**DOCUMENT 00 90 00
ADDENDUM**

ADDENDUM NO. [2] M Date: April 4, 2018

**RE: WITC – SUPERIOR CAMPUS
SUPERIOR INTERIOR AND EXTERIOR MAINTENANCE & REMODEL
600 N 21ST STREET
SUPERIOR, WI 54880
HSR PROJECT NO. 17063-1**

FROM: HSR Associates, Inc
100 Milwaukee Street
La Crosse, WI 54603
(608) 784-1830

WITC - SUPERIOR CAMPUS
SUPERIOR INTERIOR AND EXTERIOR
MAINTENANCE & REMODEL
600 N. 21st Street
Superior, Wisconsin 54880
ELECTRICAL - DEMOLITION PLAN

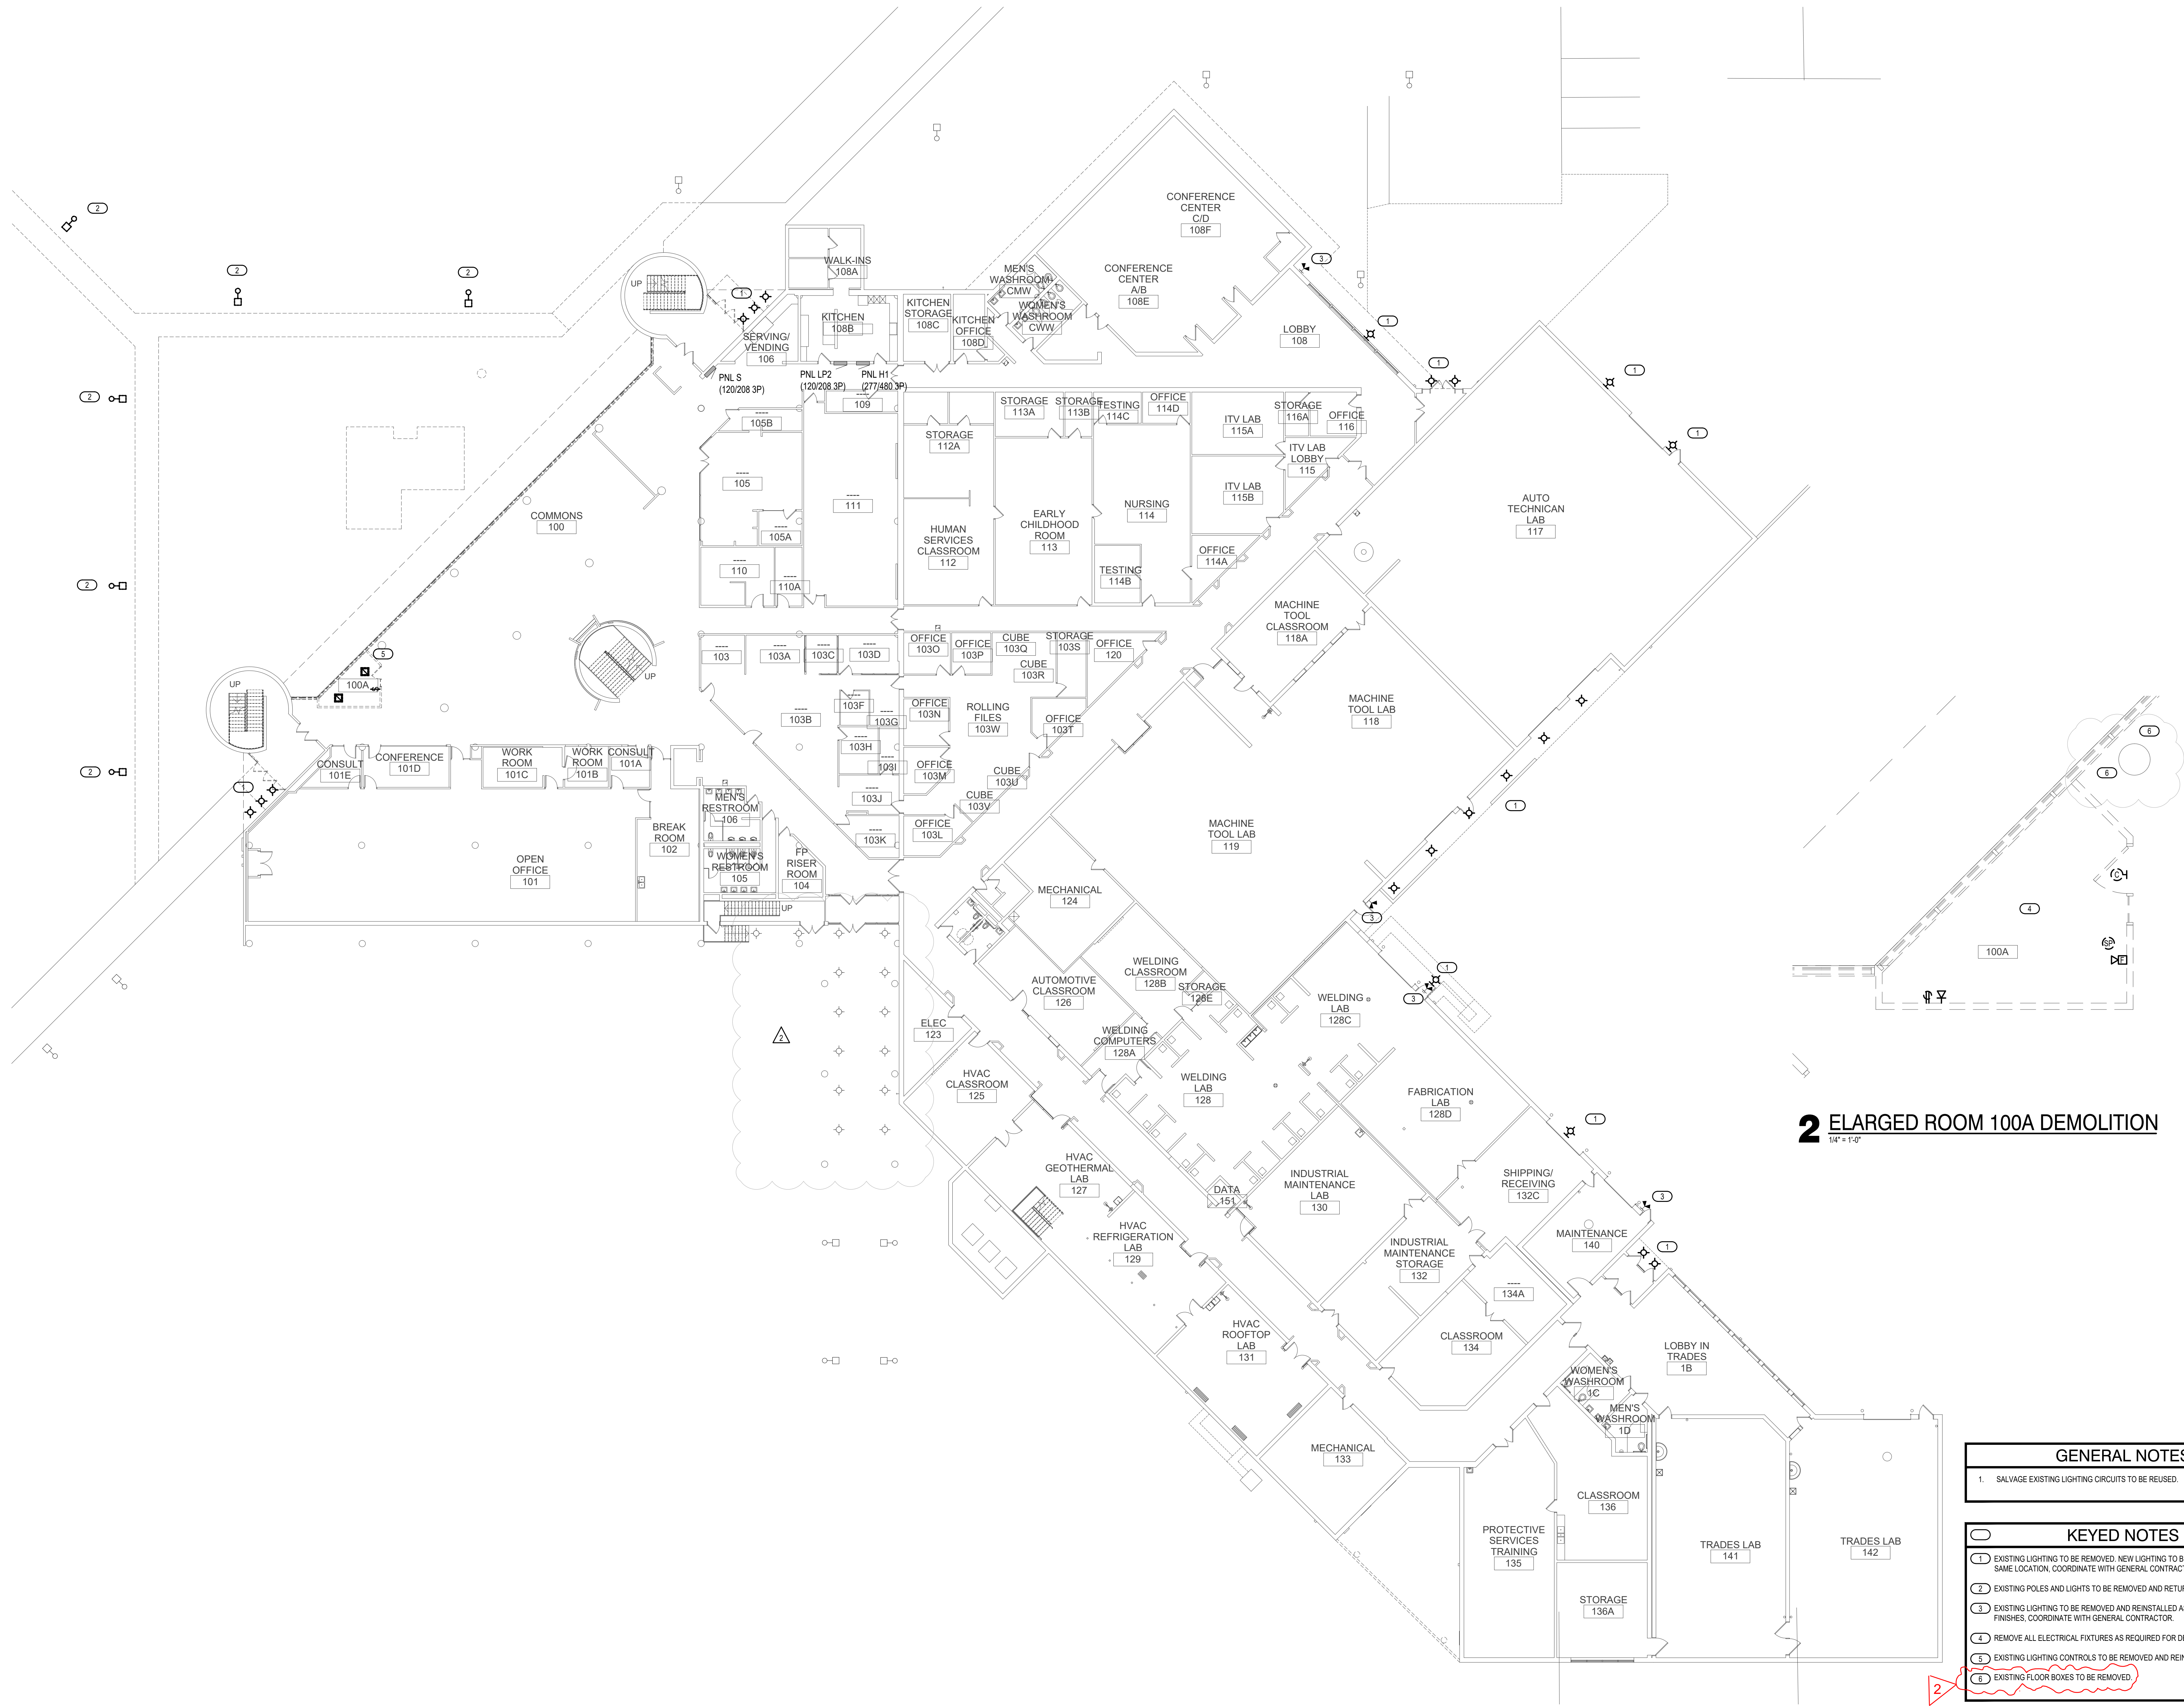
- c. Relocated SG-1 into ceiling space.
20. Sheet ED101R ELECTRICAL – DEMOLITION PLAN 30 x 42 attached hereto
 - a. Revisions clouded on Drawing.
 - b. Existing light fixtures to remain added to plan.

- c. Added Key Note 6.
21. E101R ELECTRICAL – LIGHTING PLAN 30 x 42 attached hereto
 - a. Revisions clouded on Drawing.
 - b. Added Key Note 6.
 - c. Clarified lighting as an alternate bid item.
